SQIDEP independent evaluators joint report:

Atlan FlowFilter

DesignFlow & Manly Hydraulic Laboratory

August 2024

Figure 5 - Example events where inflow and outflow at the Costco site were significantly different

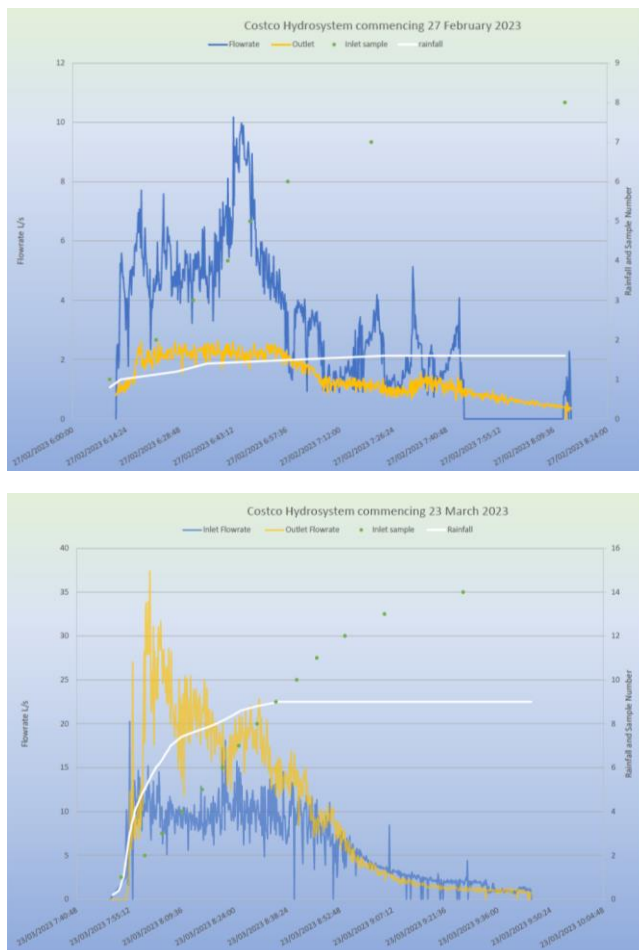
The Unidata Doppler flow units were used for the in-field flow monitoring of this stormwater unit. Although Atlan have stated they were calibrated, there is no evidence provided for on-site Site calibration as required in the specifications from UniData.

Both flow meters appear to have been poorly installed, with the sample tube close to the Doppler sensor head and cabling not well secured leading to ragging and blocking of the sensor heads. Small weirs were installed downstream of the sensor, but these also have the potential to create ragging. The resulting flow monitoring appears to have significant errors in many events as shown with mass balance issues between the upstream and downstream gauges for a number of events (*Figure 5*). It is not clear whether the inflow rate or outflow rate are more accurate. Therefore, the flow rate information submitted does not provide a reliable understanding on the treatment flow rate.

Subsequent laboratory testing of a filter cartridge removed from the Costco FlowFilter device (Waterlabs Australia, July 2024) against the draft Stormwater Australia's laboratory testing protocol (Stormwater Australia) has confirmed a treatable flow rate of 4 L/s.

The assessors have concerns with the flow monitoring data collected in the field at Costco and believe the data cannot be used to define a treatment flow rate for the Atlan Flowfilter. Therefore, the laboratory data collected by Waterlabs Australia has been used by the assessors to define treatment flow rates for this assessment only.
